TECH MEMO

4900 Series Deadlatch

SW06001	04-18-2006

Radius Bolt

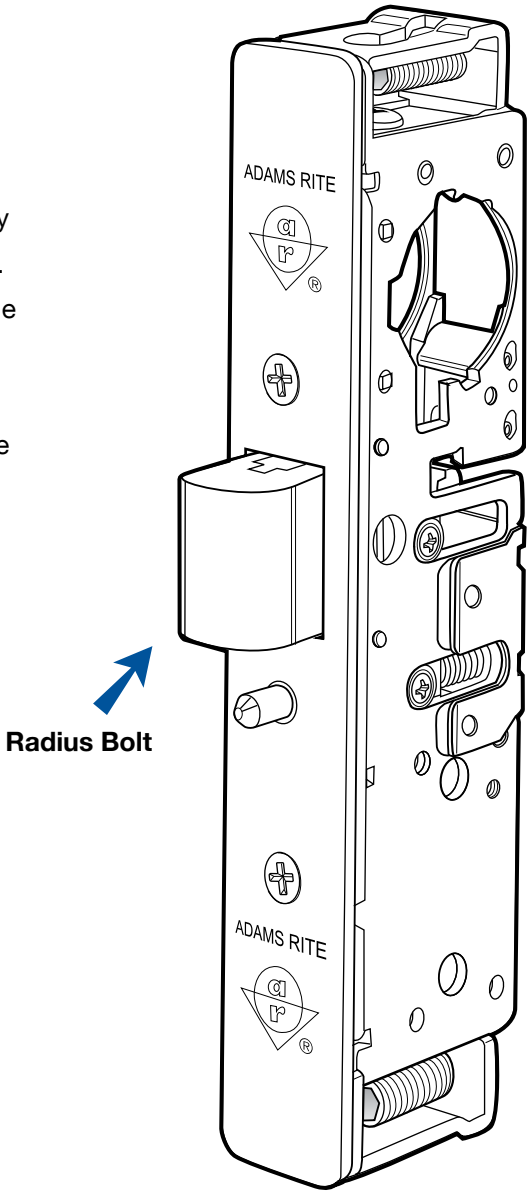
To resolve a problem with the release of the 4900 series deadlatch when used with shallow-depth electric strikes, an adjustment has been made to the lock case and the main latchbolt of all 4900s.

While the 5/8" latchbolt length has not been altered, the main latchbolt has been provided with more free-play to move back when in the deadlatched position. The extra play allows the bolt to conform to the depth of the electric strike. Even in tight door gap conditions, the latch releases from the electric strike with ease.

The new configuration is identified by the latchbolt shape – the new 4900s have a radius front main latchbolt. The original version had a beveled front bolt. For further details, please contact Adams Rite technical support at 800-872-3267.
